State of New Mexico  
Energy, Minerals and Natural Resources

SUNDRY NOTICES AND REPORTS ON WELLS (DO NOT USE THIS FORM FOR PROPOSALS TO DRILL OR TO DEEPEN OR PLUG BACK TO A DIFFERENT RESERVOIR. USE "APPLICATION FOR PERMIT" (FORM C-101) FOR SUCH PROPOSALS.)	
1. Type of Well: Oil Well <input type="checkbox"/> Gas Well <input checked="" type="checkbox"/> Other	
2. Name of Operator EOG Resources, Inc.	
3. Address of Operator 104 South Fourth Street, Artesia, NM 88210	
4. Well Location Unit Letter <u>P</u> : <u>660</u> feet from the <u>South</u> line and <u>810</u> feet from the <u>East</u> line Section <u>2</u> Township <u>10S</u> Range <u>26E</u> NMPM <u>Chaves</u> County	
11. Elevation (Show whether DR, RKB, RT, GR, etc.) 3,899' GR

# Casino AXC St #2

API: 30-005-63402  
GL: 3,899'  
KB:

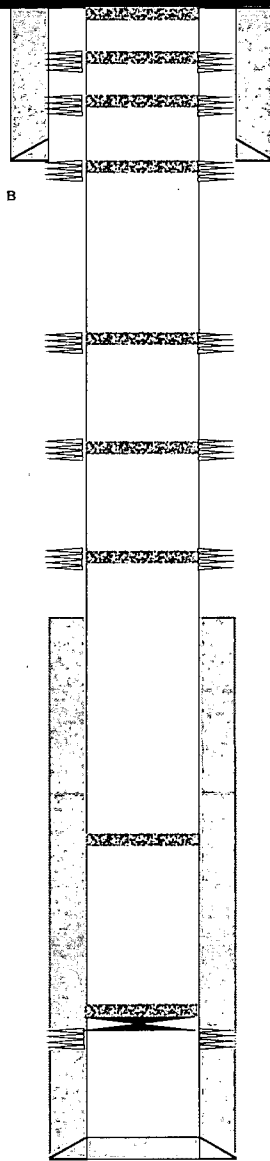
6. Perforate at 2522 ft. Attempt to establish Circulation or spot I/O. Requires 65 SX (241 ft) CLS C cement plug 2281 ft - 2522 ft. WOC & Tag Plug. This will plug the Yeso/Glorieta *Perf @ 1157 - shoe*
